**ADDENDUM NO. 2 TO PROJECT NO. 43153**

**CONSTRUCTION WORK, MECHANICAL WORK,  
PLUMBING WORK, ELECTRICAL WORK  
PROVIDE VISITOR CENTER BUILDING AND SITE IMPROVEMENTS  
FIVE RIVERS ENVIRONMENTAL EDUCATION CENTER  
56 GAME FARM ROAD  
DELMAR, NY 12054**

June 26, 2015

### 3 DISPLAY BOARD POST AND FOUNDATION

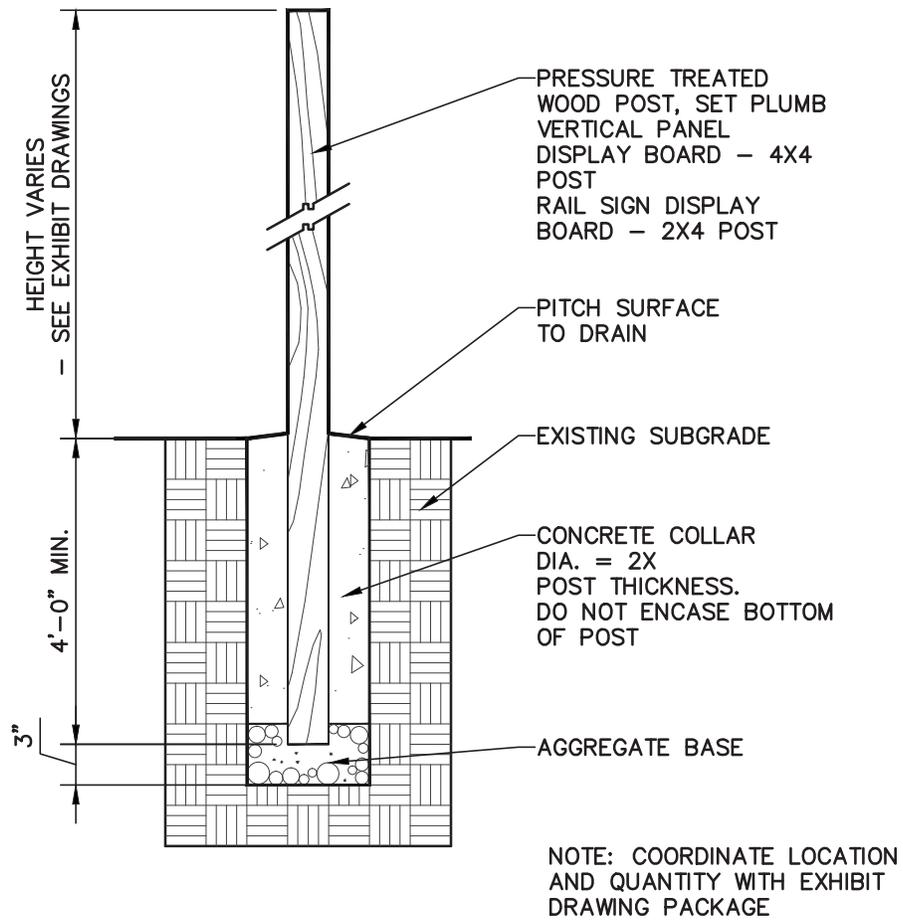
3. Sheet C-141
  - a. The benches shown on stone dust path at the corner of the covered walkway shall reference detail 8/C-509.
4. Sheet C-509
  - a. Add attached detail 3 for the display board post and foundation to sheet C-509.
